Recall Campaign Bulletin

CAMPAIGN NO.	2026040002
CAMPAIGN DESC.	26P9190320
NHTSA ID	26V172
SUBJECT	Replace Rear Center Seat Belt
MODEL(S)	GLC (254 platform)
MODEL YEAR(S)	2026
CAMPAIGN POPULATION	20

Campaign Technical Instructions

**Figure 1**

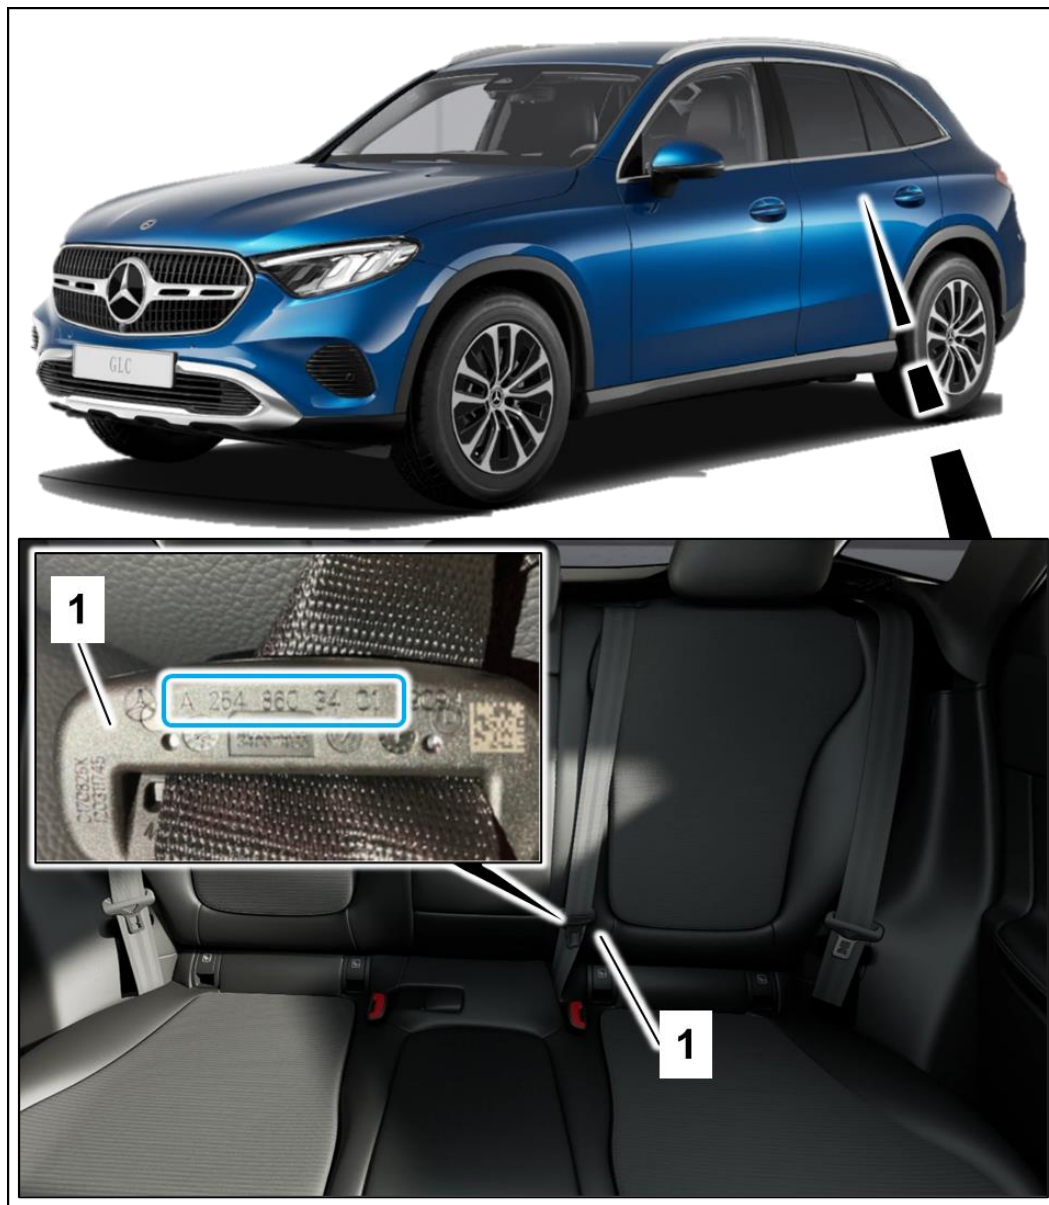
1. Check part number of belt tongue (Figure 1, 1) on the center seat belt in rear passenger compartment.

- a. If the installed belt tongue (Figure 1, 1) does **not** have **part number A 254 860 36 01 (model 254.3) or A 254 860 23 00 (model 254.6)**: Perform **Work Procedure**.
- b. If the installed belt tongue (Figure 1, 1) has **part number A 254 860 36 01 (model 254.3) or A 254 860 23 00 (model 254.6)**: No further action required.

1. Replace center seat belt in rear passenger compartment.
